STAFF HEARING OFFICER STAFF REPORT

REPORT DATE: August 11, 2016
AGENDA DATE: August 17, 2016
PROJECT ADDRESS: 1028 Olive Street (MST2015-00583)
TO: Susan Reardon, Senior Planner, Staff Hearing Officer
FROM: Planning Division, (805) 564-5470
 Danny Kato, Senior Planner *Dk*
 Megan Lowery, Associate Planner

FLOOR PLAN (N)

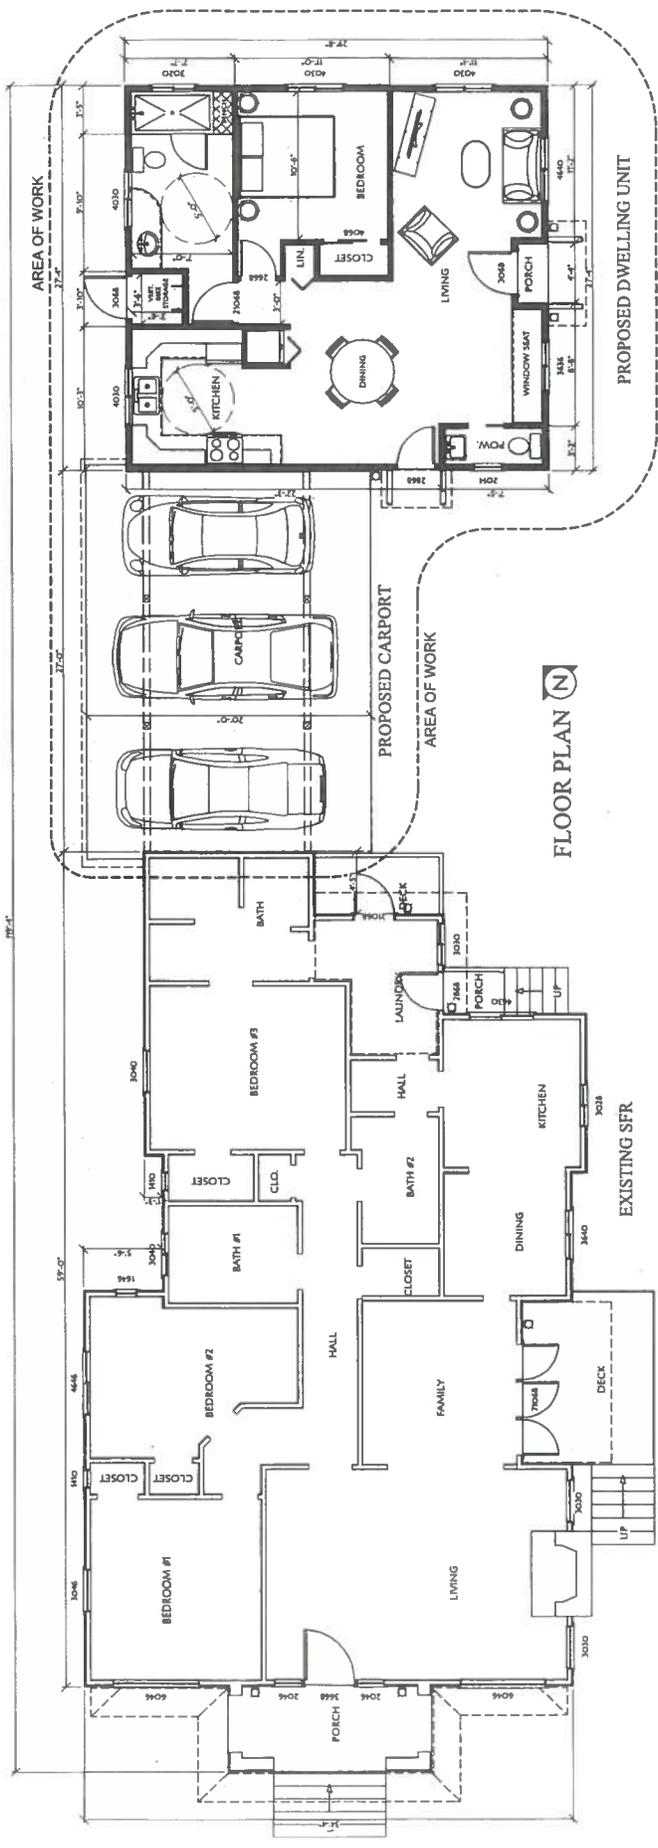
- 1) Study adding landscaping at the southeast corner facing the carport.
- 2) Study adding some glass at the secondary door facing the carport and/or adding an architectural enhancement, such as an eyebrow roof element.

- 3) Study raising the plate height at the rear unit.
- 4) Add a powder room window on the west elevation that is shown on the floor plans, and resolve other inconsistencies between the floor plan and elevations.

- 5) Return the parapet by one foot at each side at the east elevation.
- 6) **The Board has reviewed the proposed project and the Compatibility Analysis criteria (SBMC 22.22.145.B. and 22.68.045.B.) were generally met as follows:**
